S/D No.: 86-118 Name: AUTUMN CHASE ADDITION

STAFF COMMENTS:

**FINAL PLAT OF**  
**AUTUMN CHASE**  
**AN ADDITION TO WICHITA, SEDGWICK COUNTY, KANSAS**

Re: Final Plat S/D 86-118 - AUTUMN CHASE ADDITION

# FINAL PLAT OF AUTUMN CHASE

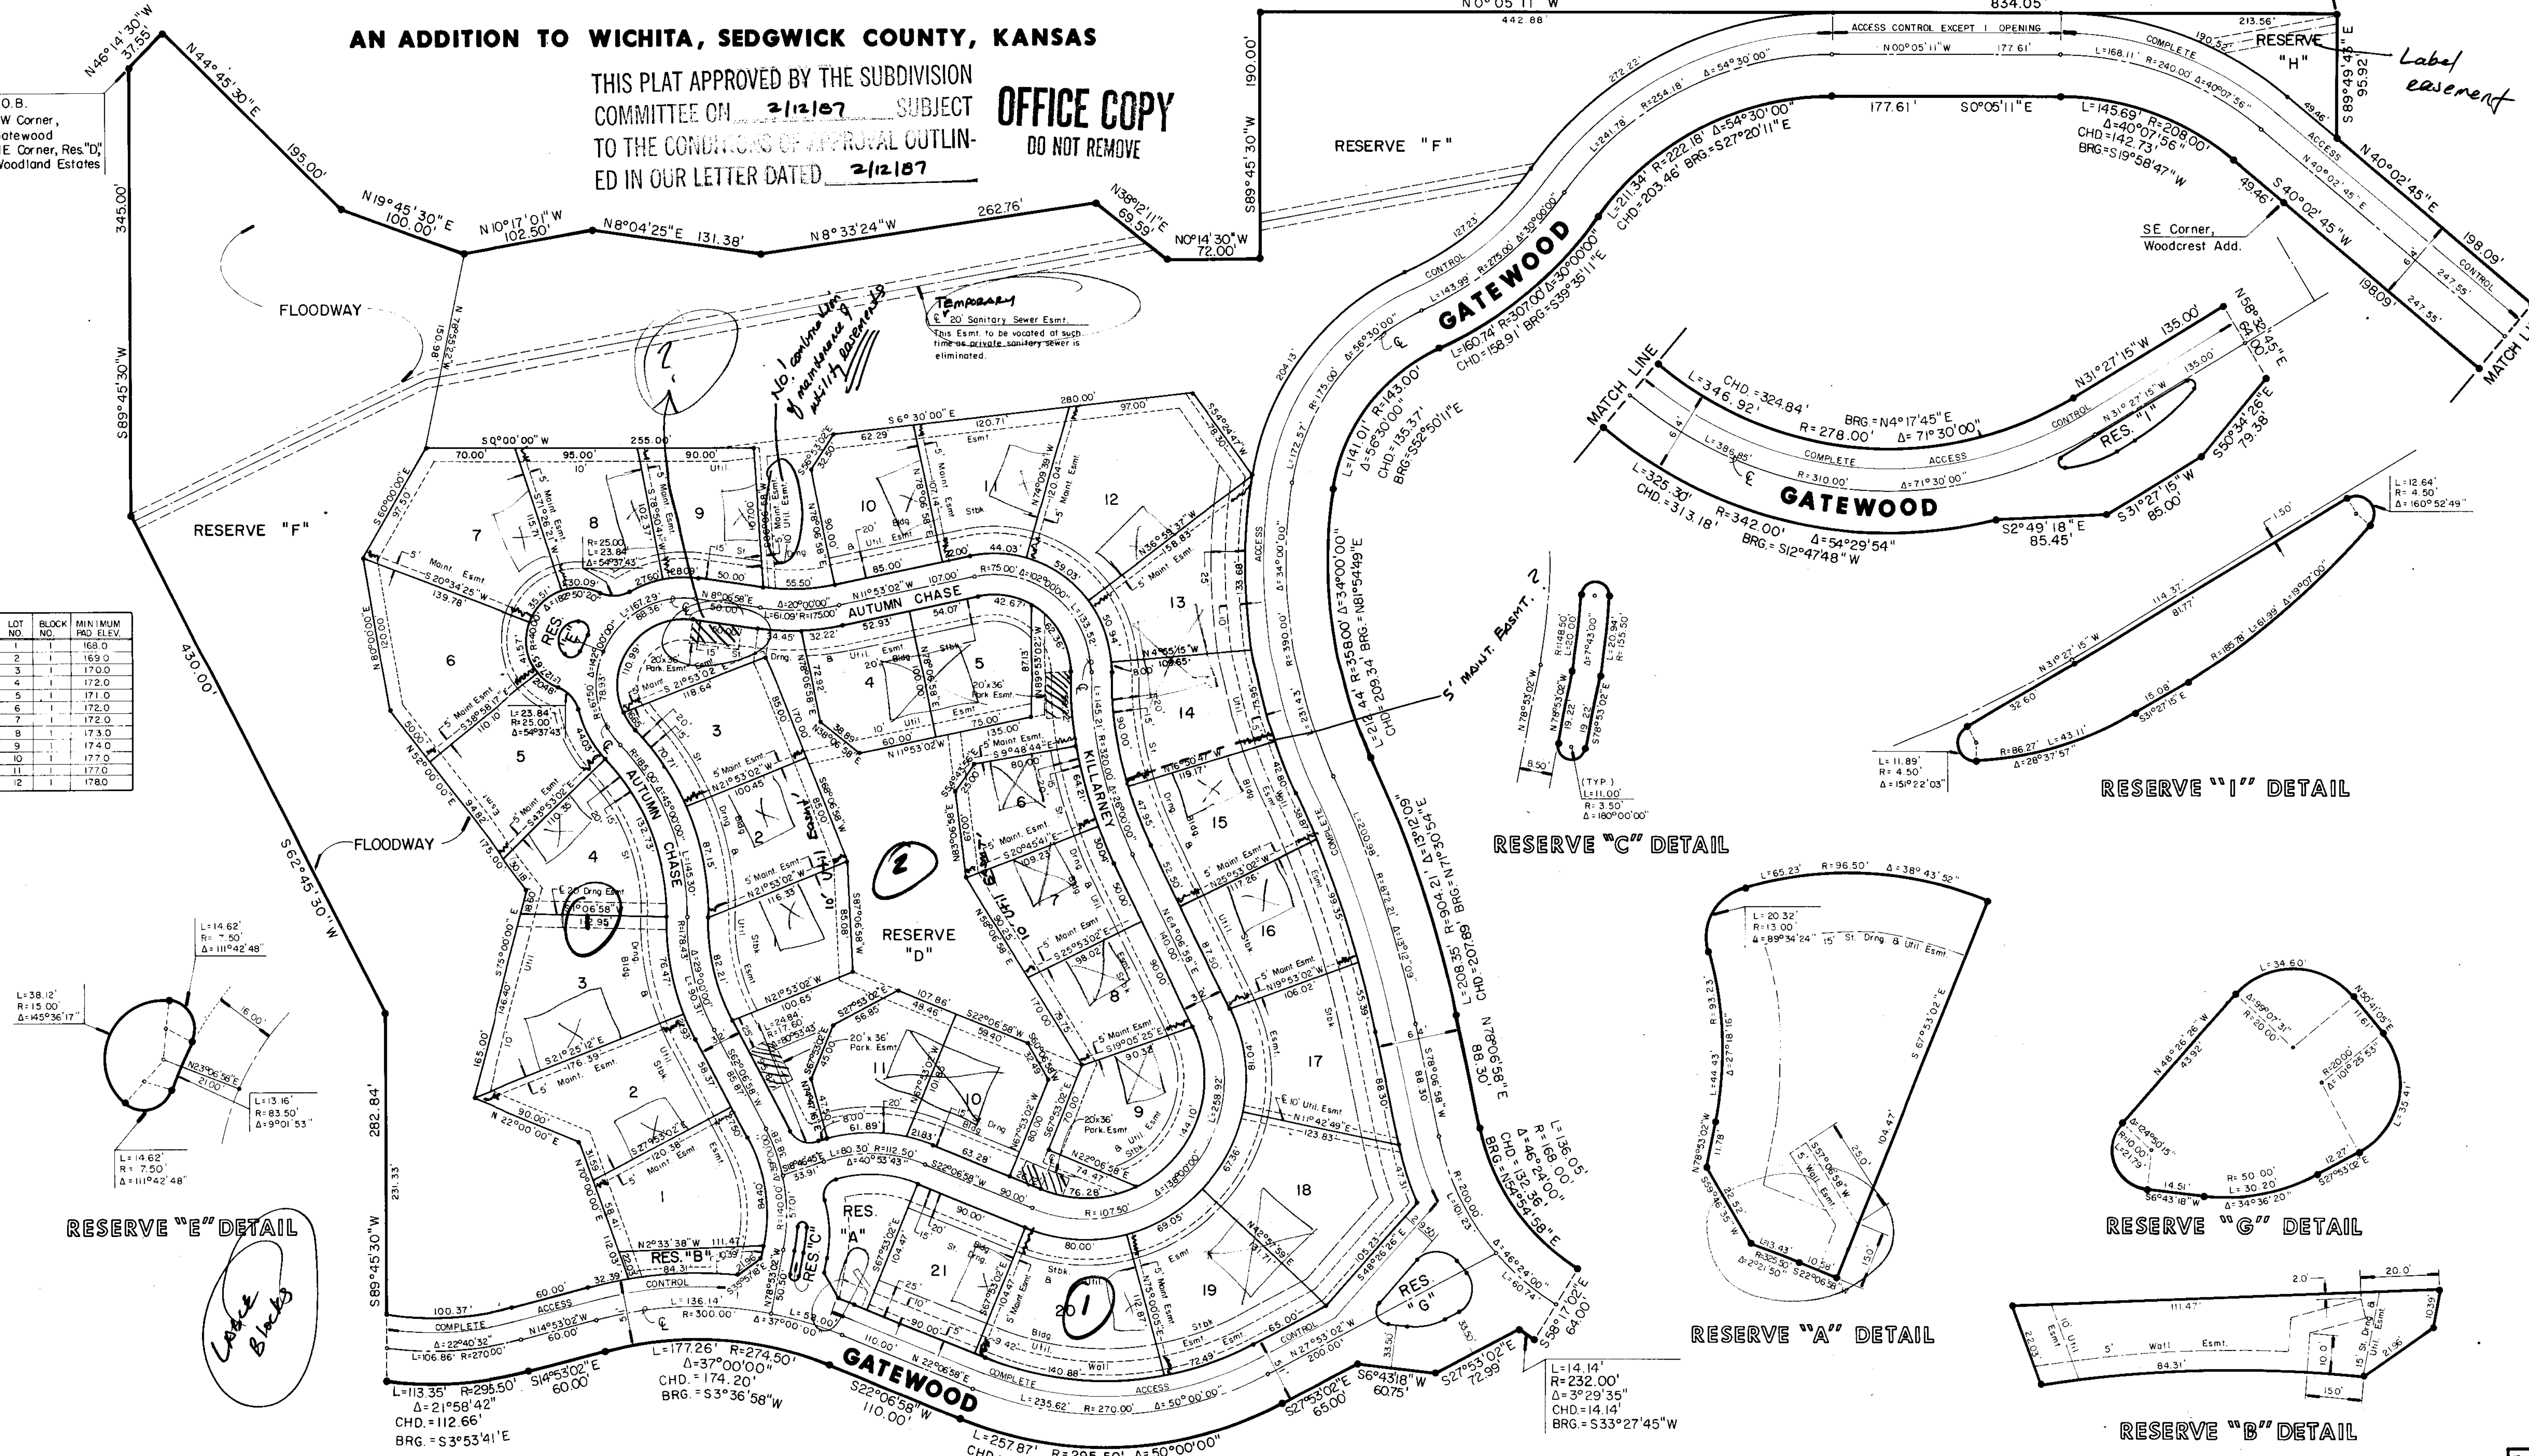
- X. On the final plat tracing, the block designations shown on the preliminary plat shall be depicted on the face of the plat.
- Y. On the final plat tracing, the type and amount of easement being platted on the east 15 feet of Reserve A shall be labeled and dimensioned.

- Z. On the final plat tracing, bearings and distances shall be provided for the centerline of the "temporary utility easement" being platted within Reserve F.

- AA. On the final plat tracing, the portion of the plat's text which references access controls, shall be amended to delete referencing the granting of access control from property which is not within the perimeter of this plat (i.e., "the easterly line of Reserve E, Woodcrest Addition).

- N. On the final plat tracing, a 5-foot wide maintenance easement needs to be platted on Lot 14, Block 1, if a zero-lot line unit is to be constructed on Lot 15, Block 1.

- T. On the final plat tracing, the 20-foot wide sanitary sewer easement within Reserve F shall be labeled as a "temporary utility easement". The note included with this easements labeling shall be amended to reference that the "temporary easement automatically is vacated upon abandonment of the private sanitary sewer lateral located in the temporary easement". If the 20-foot easement within Reserve H is a continuation of this "temporary utility easement", it shall be so labeled on the face of the plat and referenced in the plat's text.

- U. On the final plat tracing, the face of the plat shall not depict the continuation of the proposed 5-foot wide maintenance easement into platted street, drainage and public utility easements. The maintenance easements shall also not be shown extending into rear lot line utility easements. The maintenance easement is being platted not only for maintenance of adjacent structures, but also for a 2-foot wide roof overhang. Building overhangs are not permitted within utility, drainage or street easements.

- V. The final plat tracing shall omit the platting of the "5-foot wide maintenance easement" within the 10-foot wide utility easement adjacent to the north line of Lot 9. Roof overhangs are not permitted within utility easements. It is suggested that the 10-foot utility easement be moved 5 feet to the north within Reserve F.

- W. On the final plat tracing, the 10-foot wide utility easement being platted on the rears of Lots 6 through 11 and Lots 1 through 3, Block 2 (interior block as shown on preliminary plat), shall be labeled.

*A portion of*  
*What?!*  
*What!!!*  
*Mention state yard req. by virtue of C.O.P. (Item P of Prelim No.)*

RESERVE "G" DETAIL

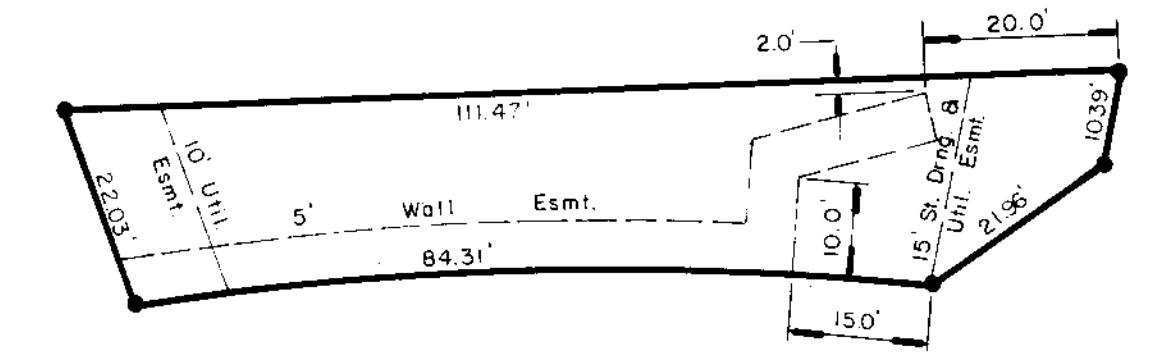
- FF. The representatives from City Engineering and Traffic Engineering should be prepared to comment on the acceptability of the "intersection geometrics" proposed for the Autumn Chase/Gatewood intersection and the Gatewood intersection around Reserve G. Also, are the geometrics proposed for Gatewood right-of-way around Reserve I acceptable?
